WILLIAMSON COUNTY, TEXAS

CHANGE ORDER NUMBER: 4

**County Road 110 South
Williamson County Project No. 1604-075**

Change Order No. 4

DESIGNED:		TGL	
DRAWN:		PRP	
CHECKED:		GV	
STATE	COUNTY	PRECINCT	SHEET NO.
TEXAS	WILLIAMSON	4	103

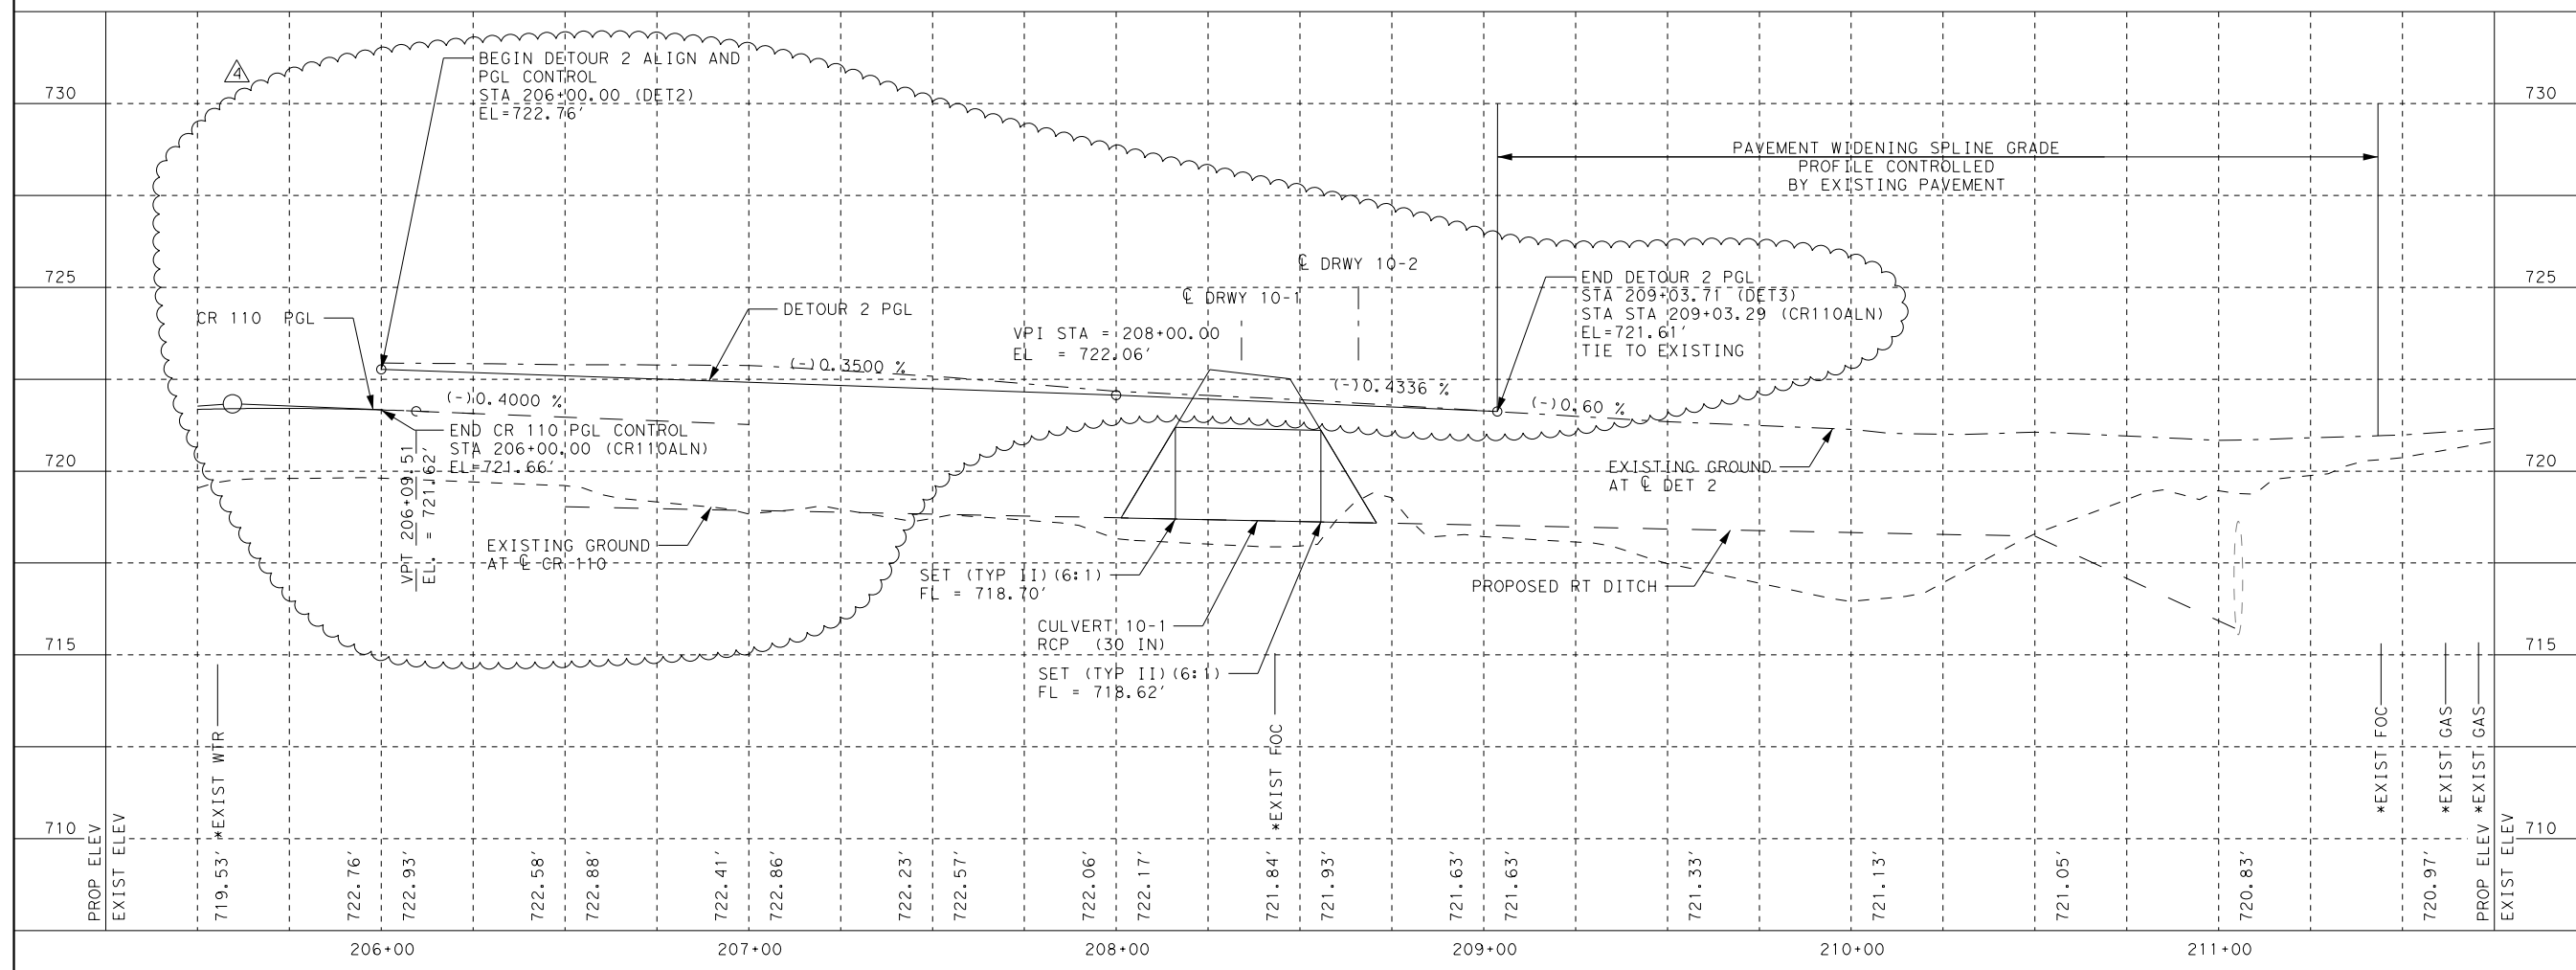
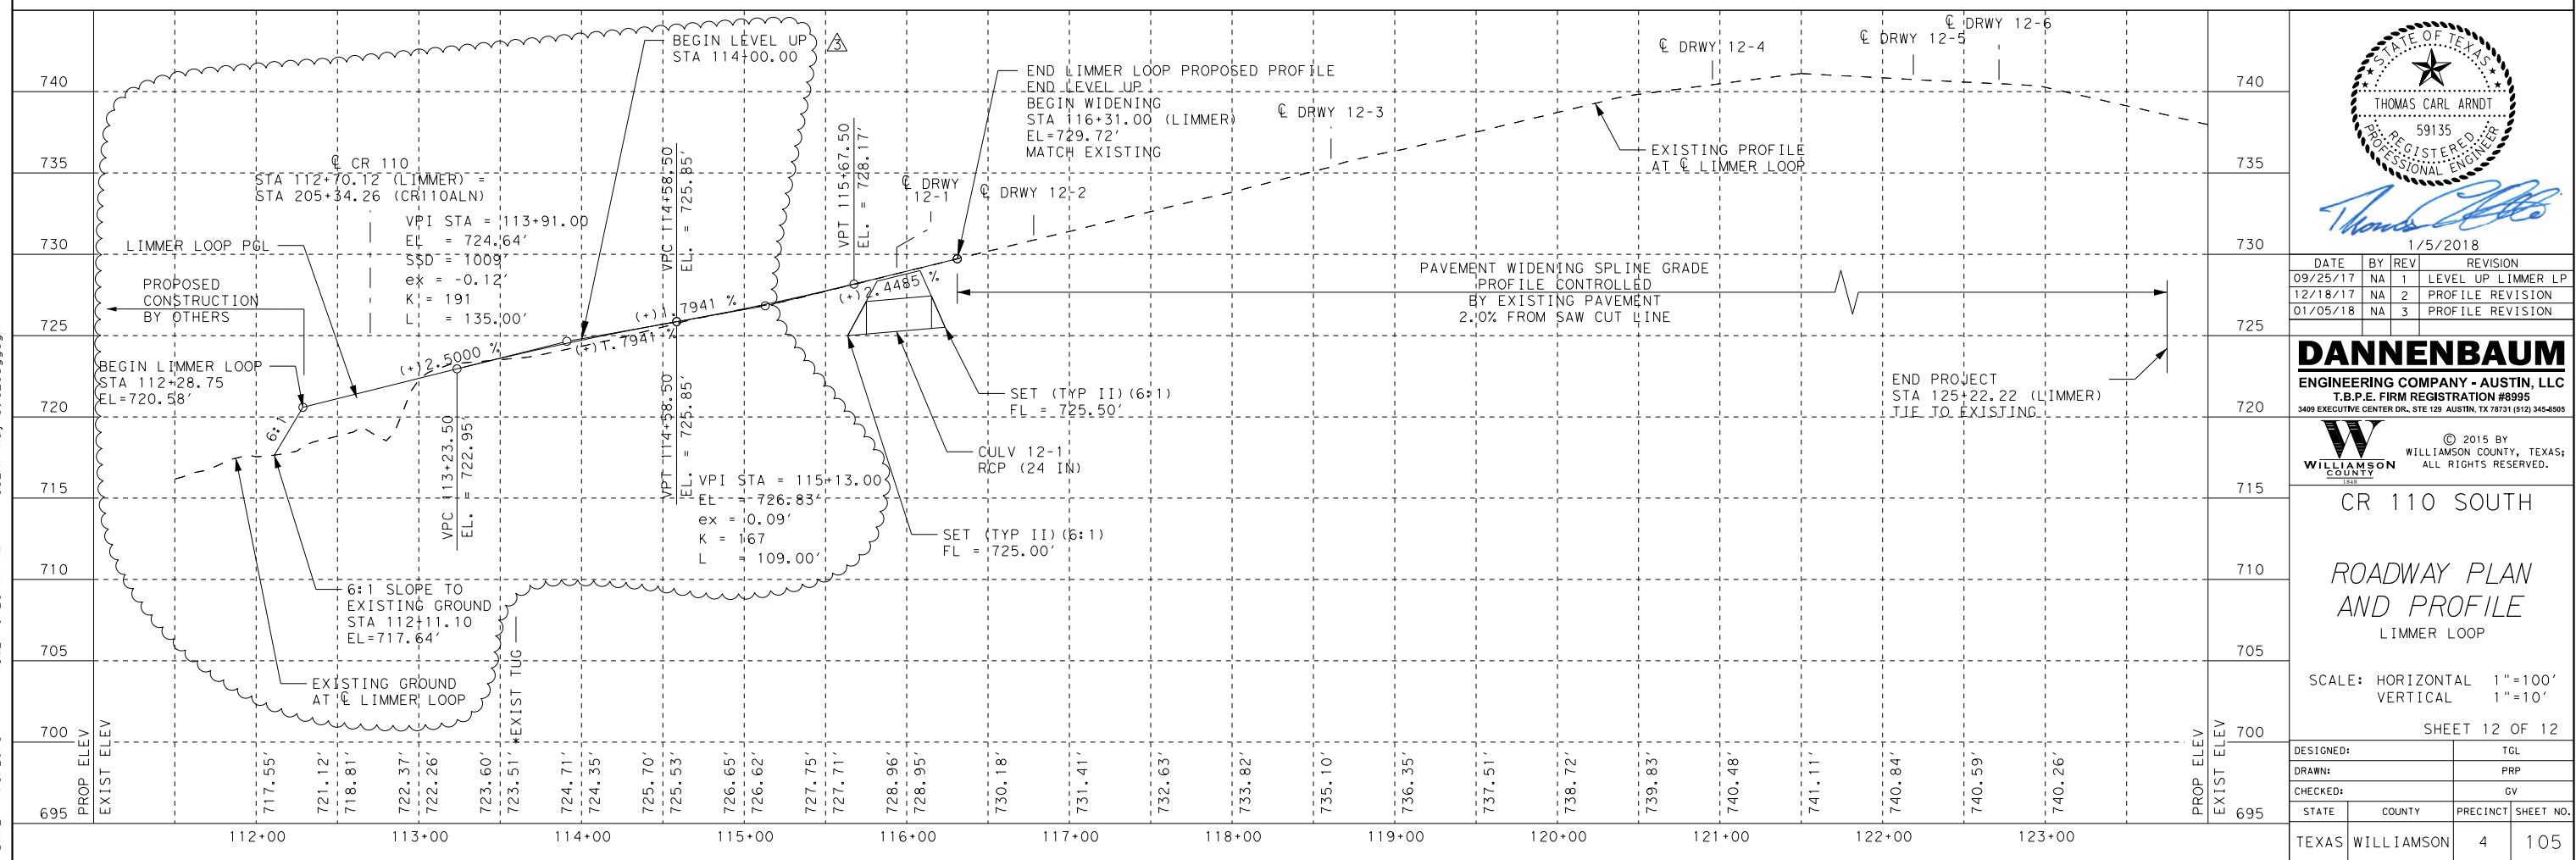
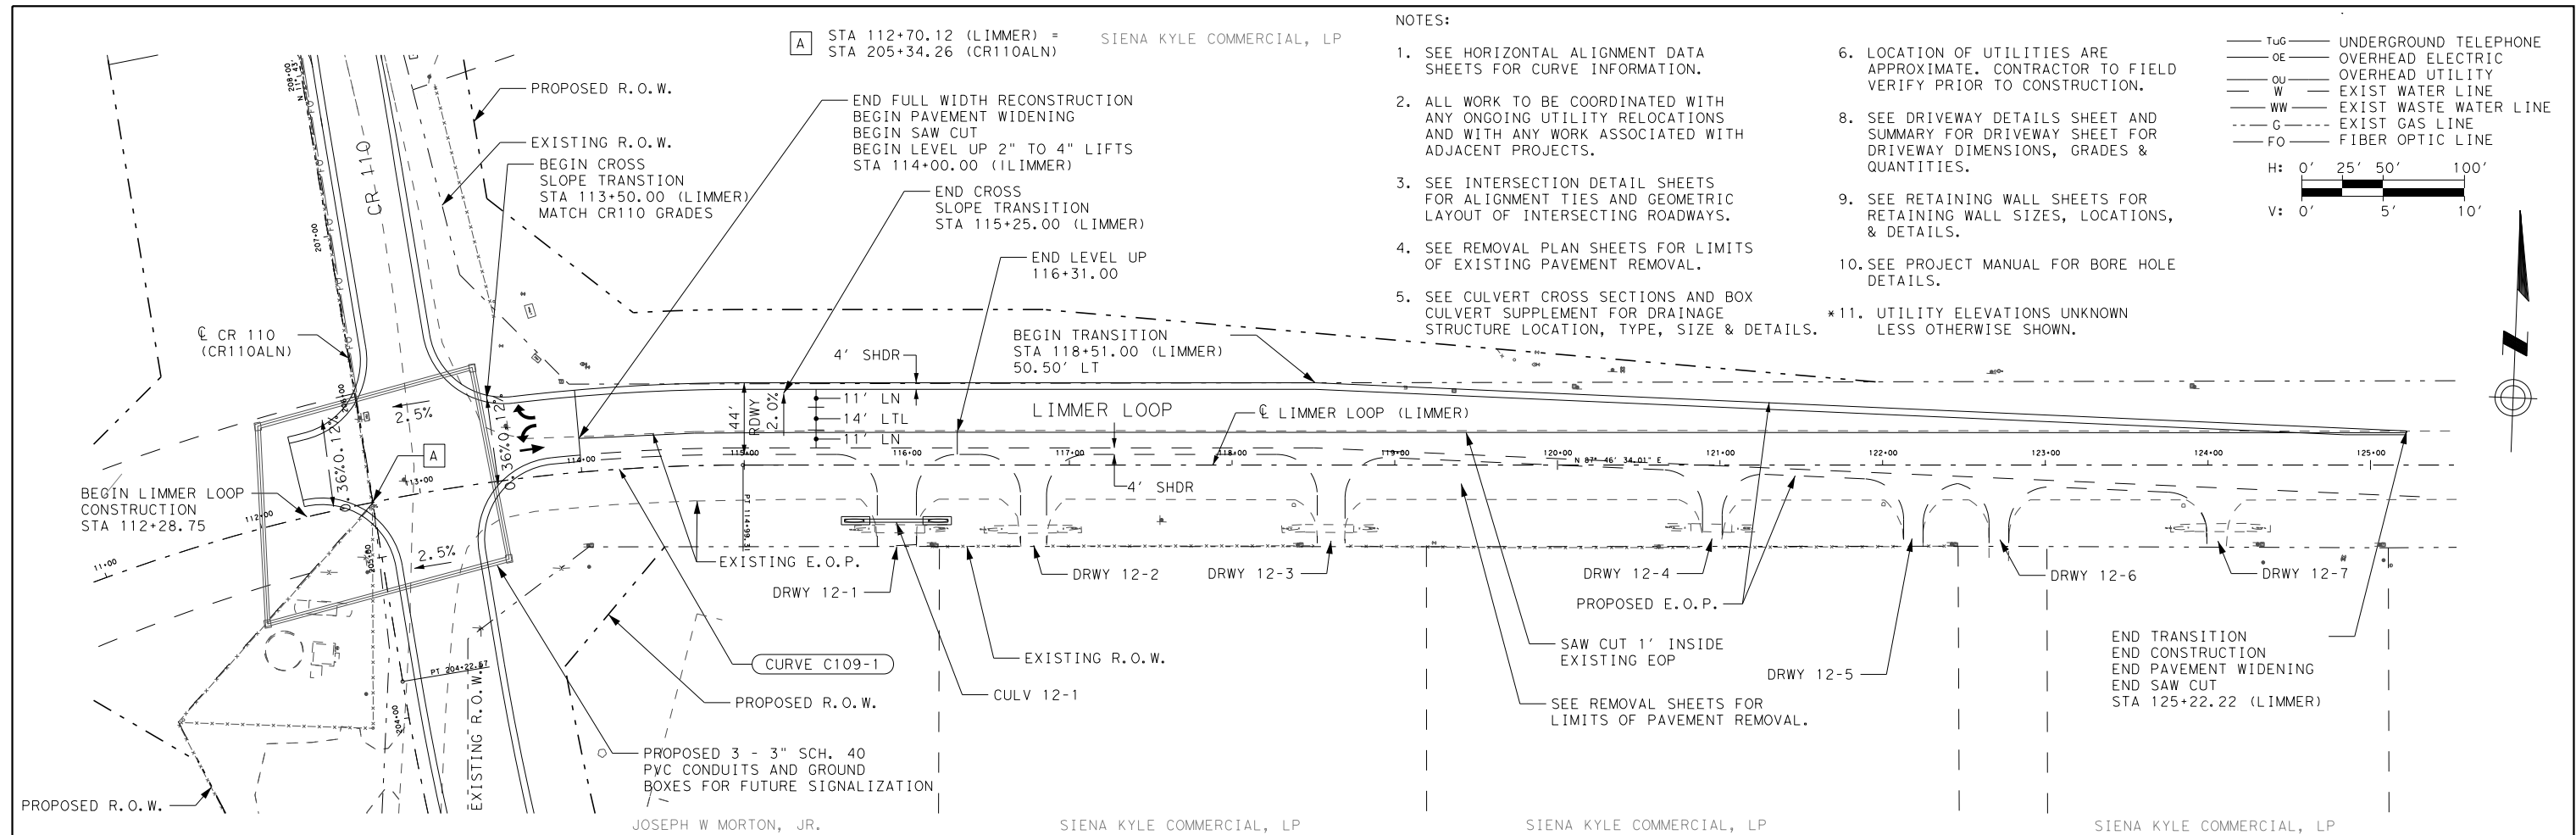
This Change Order revises the north end of the project tying into existing CR 110 by shortening the limits due to an unacquired Right of Way tract. The proposed roadway taper to existing pavement is shortened to stay within acquired limits. This also simplifies the construction of Limmer Loop by notching and widening adjacent to the roadway rather than full pavement construction. Additional quantity for Type D PG 70-22 asphalt is added to pave the full width of Limmer Loop, rather than just the widening shown in the plans.

Plan sheets 102, 103, and 105 are revised. Cross-section sheets 85 thru 88 and 96 thru 98 are replaced.

END FULL WIDTH RECONSTRUCTION
BEGIN PAVEMENT WIDENING
STA 209+03.71 (DET2)
STA STA 209+03.29 (CR110ALN)
